PRODUCT/PROCESS CHANGE NOTIFICATION

SUBJECT **L9781 (UI15) : TEST FLOW OPTIMIZATION**

New Flow

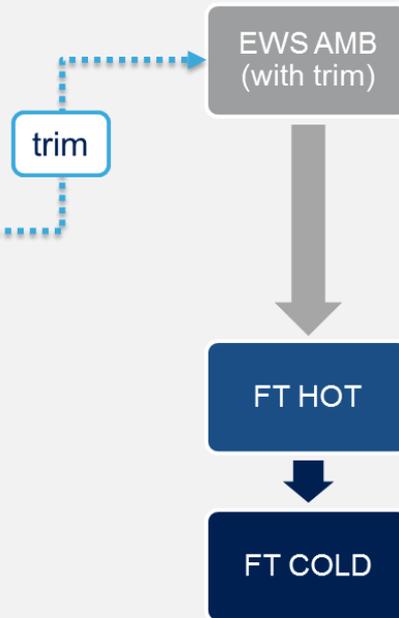
<p>IMPACTED PRODUCTS</p>	<p>ST Line UI15 assembled in LQFP 64 10x10x1.4 package:</p> <ul style="list-style-type: none">  L9781  L9781TR
<p>MANUFACTURING STEP</p>	<p>Electrical Wafer Probing (EWS) and Final Test (FT)</p>
<p>INVOLVED PLANT</p>	<p>ST Agrate Plant (Italy) – for EWS ST Muar Plant (Malaysia) - for FT</p>
<p>CHANGE REASON</p>	<p>Manufacturing process optimization (Service and Capacity improvement)</p>
<p>CHANGE DESCRIPTION</p>	<p>Optimization of product electrical test flow, by moving the device trimming from FT AMB step to EWS AMB step and removing FT AMB step maintaining full overall test coverage (Test Programs). See following diagram:</p>

Trimming function (internal references), previously performed at FT, has been moved to EWS step, performed at the same AMB temperature.
